Access Compliance Report Public Rights-of-Way (Curb Ramps)

Main Street: HAZARD_RD Cross Street: BEACH_BLVD Location: N

ADA ID: RPRK220202124237 Ramp Type: Type 4 - Parallel Initial Pass/Fail: Fail Overall Compliance: No Severity Score: 16

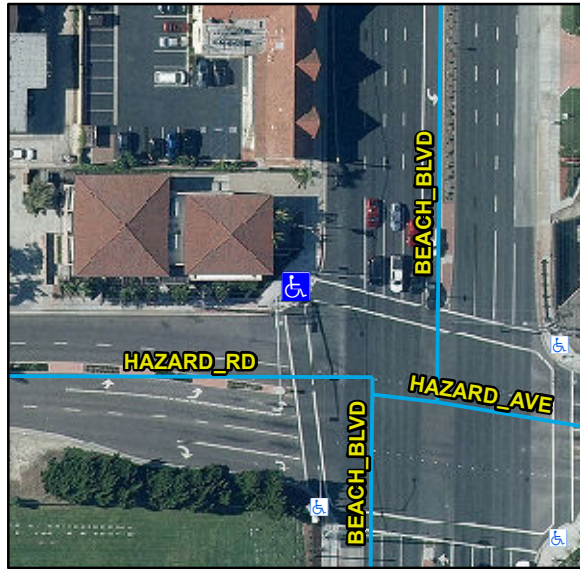
Compliance	Description	Data	Compliance	Description	Data
N/A	Ramp Length LT (in)	105	N/A	Ramp Length RT (in)	103
Yes	Ramp Width LT (in)	190	Yes	Ramp Width RT (in)	190
Yes	Ramp Run Slope LT (%)	4.8	No	Ramp Run Slope RT (%)	8.6
Yes	Ramp Cross Slope LT (%)	2	Yes	Ramp Cross Slope RT (%)	0.1
N/A	Landing Present	N/A	N/A	DWS Provided	N/A
N/A	Landing Length (in)	N/A	N/A	DWS Contrast	N/A
N/A	Landing Width (in)	N/A	N/A	DWS Length (in)	N/A
N/A	Landing Run Slope (%)	N/A	N/A	DWS Full Width	N/A
N/A	Landing Cross Slope (%)	N/A		DWS Offset Type	N/A
N/A	Landing Movement Obstructed?	N/A	N/A	DWS Offset Left (in)	N/A
	Landing Movement Type	N/A	N/A	DWS Offset Right (in)	N/A
N/A	Landing Shared	N/A			
N/A	Clear Space	Yes			
N/A	Clear Space To Crosswalk (in)	48			
N/A	Marked Crosswalk 1	Yes	N/A	Marked Crosswalk 2	Yes
	Crossing 1 Direction	S		Crossing 2 Direction	SE
	Marked Crosswalk 1 Width (in)	144		Marked Crosswalk 2 Width (in)	144

N/A	Ramp Inside Crosswalk 1	Yes	N/A	Ramp Inside Crosswalk 2	Yes
	Crossing 1 Slope (%)	2.2		Crossing 2 Slope (%)	7.6
	Crossing 1 Cross Slope (%)	1.8		Crossing 2 Cross Slope (%)	0.7
N/A	Gutter Ponding	N/A	N/A	Curb Slope	2.6
Yes	Gutter Lip Height (in)	0		Road Run Slope (%)	1.2
N/A	Gutter Run Slope (%)	N/A		Road Cross Slope (%)	5.8
N/A	Gutter Cross Slope (%)	N/A	Yes	Perpendicular Joint Present	Yes
Yes	Overall Surface Condition	Acceptable			
	Cross Gutter Present?	No		Spandrel Present?	No
	Replace Cross Gutter?	N/A		Replace Spandrel?	N/A

Remove & Replace Curb Ramp With Two New Directional Ramps or Equivalent.

R304.3.2, STD 1115
